MATERIAL LIST

REVISIONS

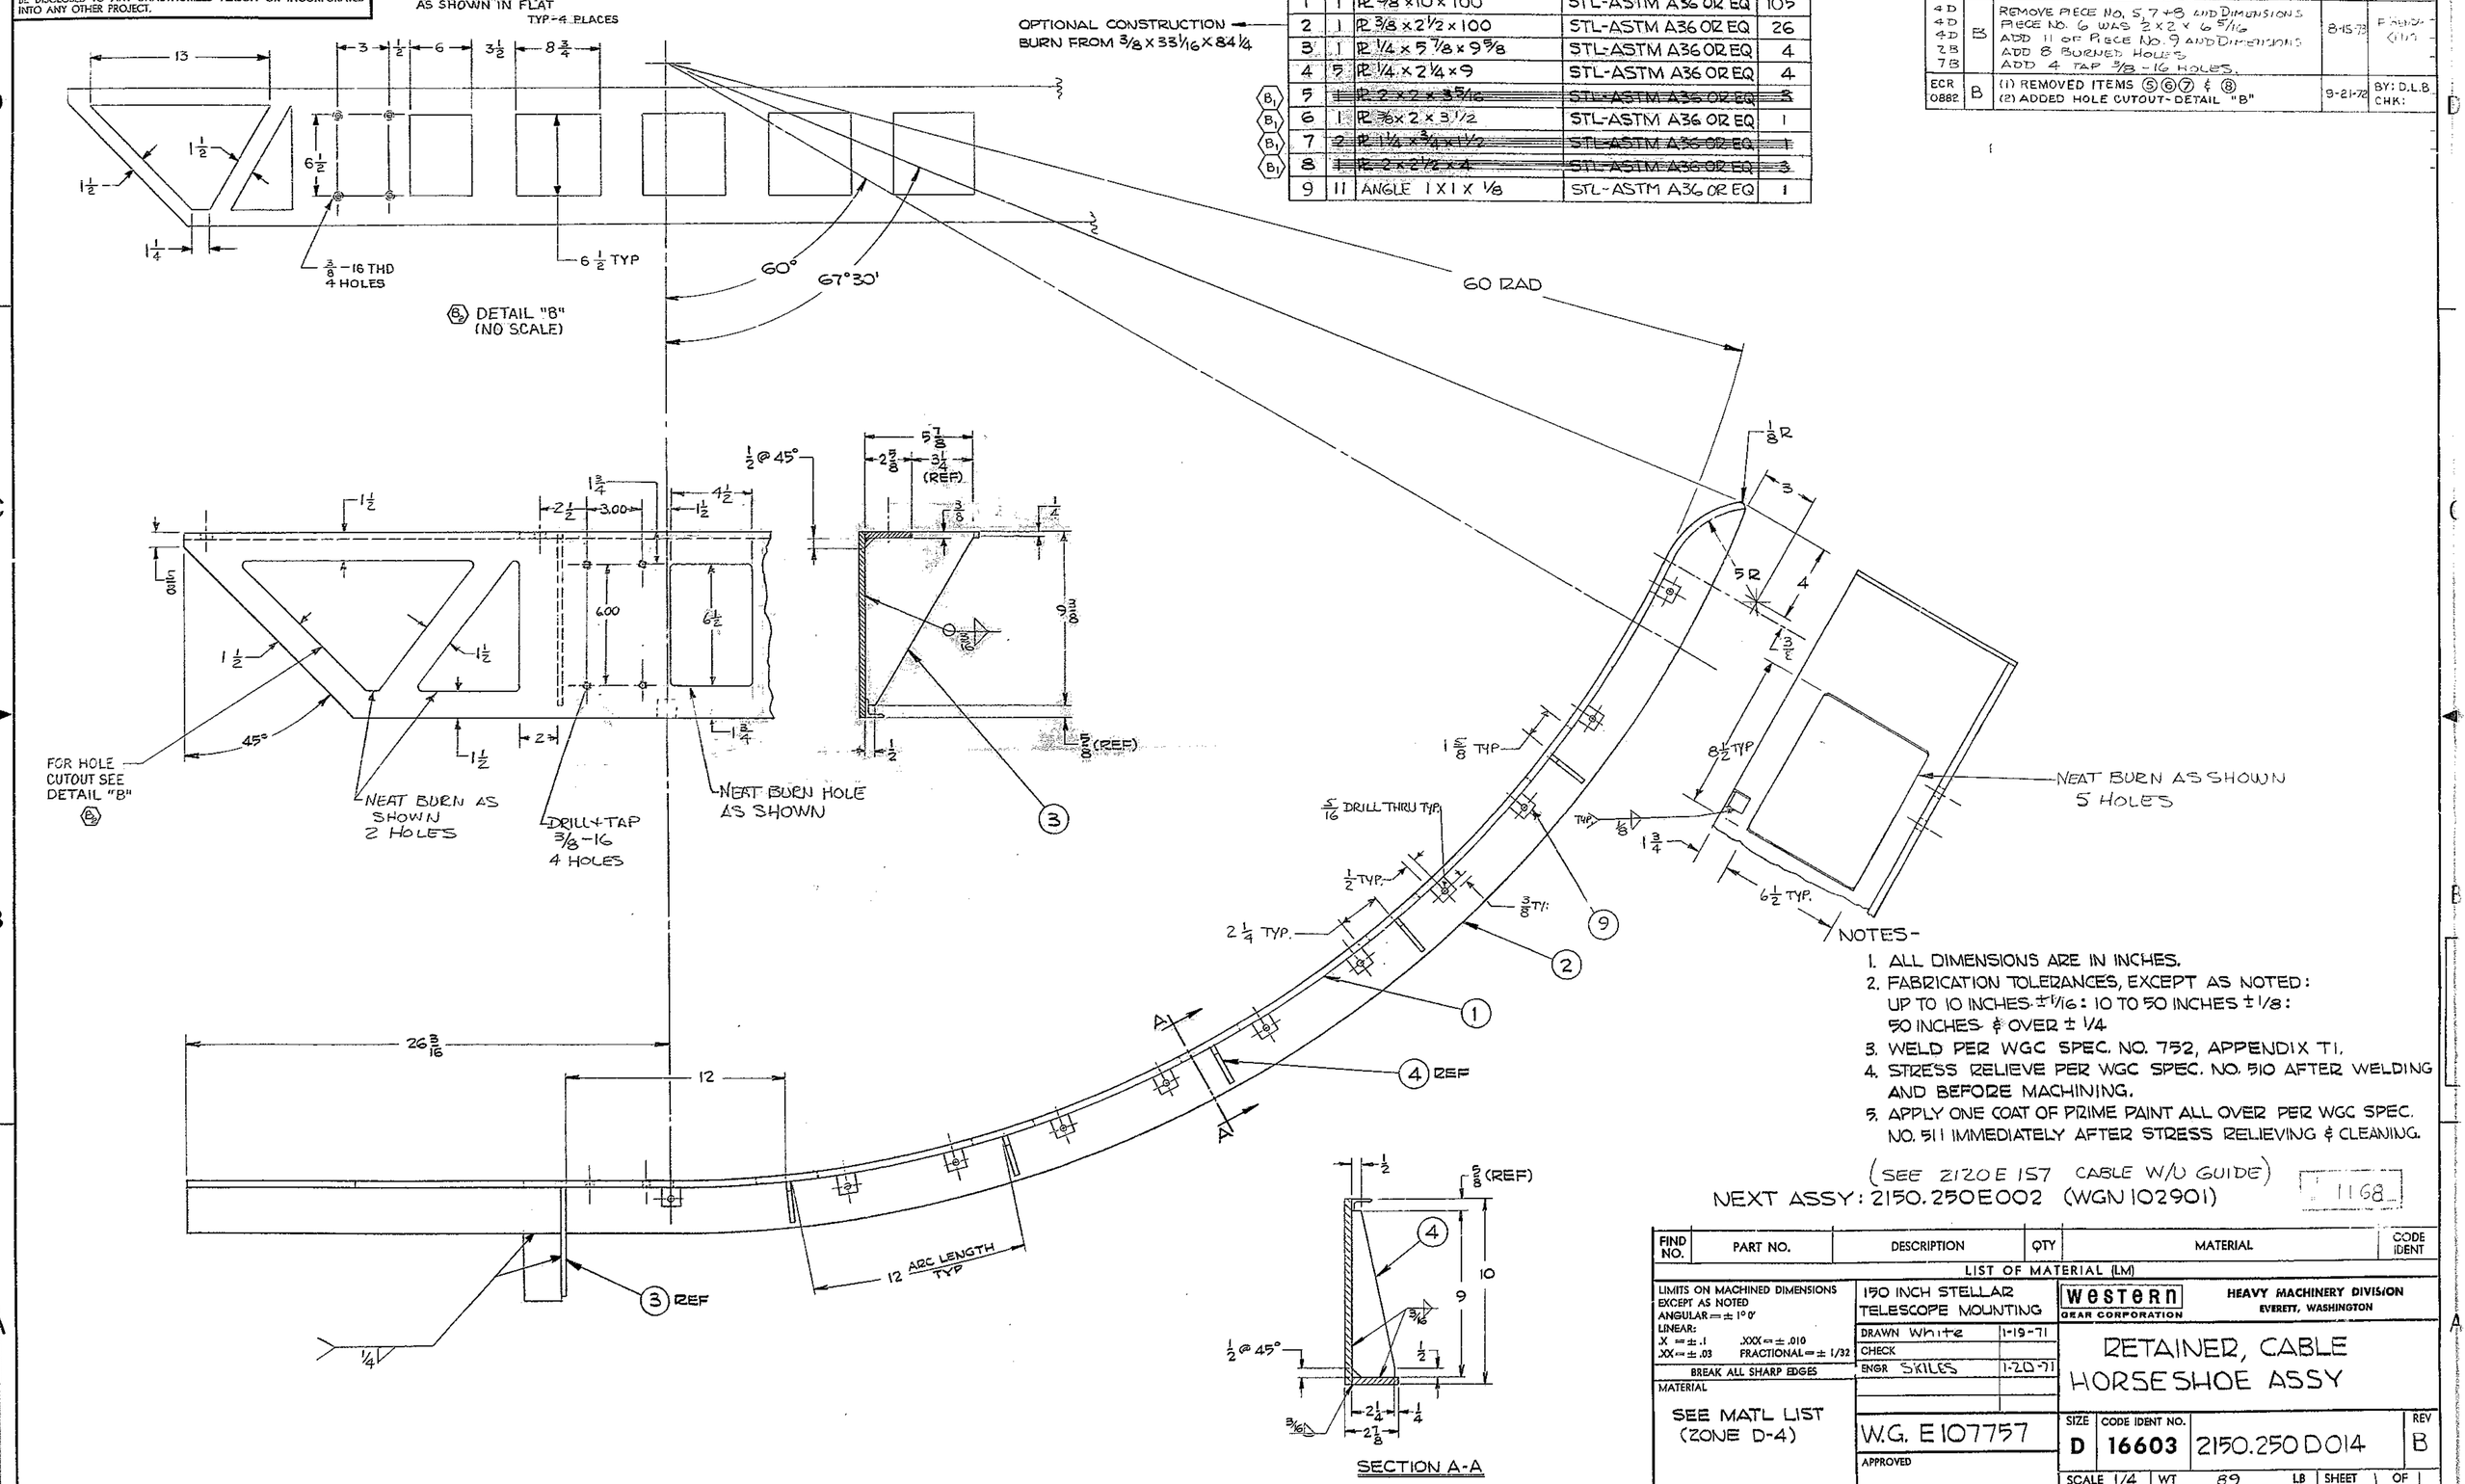
ZONE	LTR	DESCRIPTION	DATE	APPROVED
	A	RELEASED FOR MANUFACTURE	1-19-71	
4D 4D 4D 7B 7B	B	REMOVE PIECE NO. 5, 7 + 8 AND DIMENSIONS. PIECE NO. 6 WAS 3 X 2 X 6 5/16. ADD 11 OF PIECE NO. 9 AND DIMENSIONS. ADD 8 BURNED HOLES. ADD 4 TAP 3/8-16 HOLES.	8-15-73	[illegible]
ECR 0882	B	(1) REMOVED ITEMS 5 6 7 & 8 (2) ADDED HOLE CUTOUT-DETAIL "B"	9-21-72	BY: D.L.B. CHK:
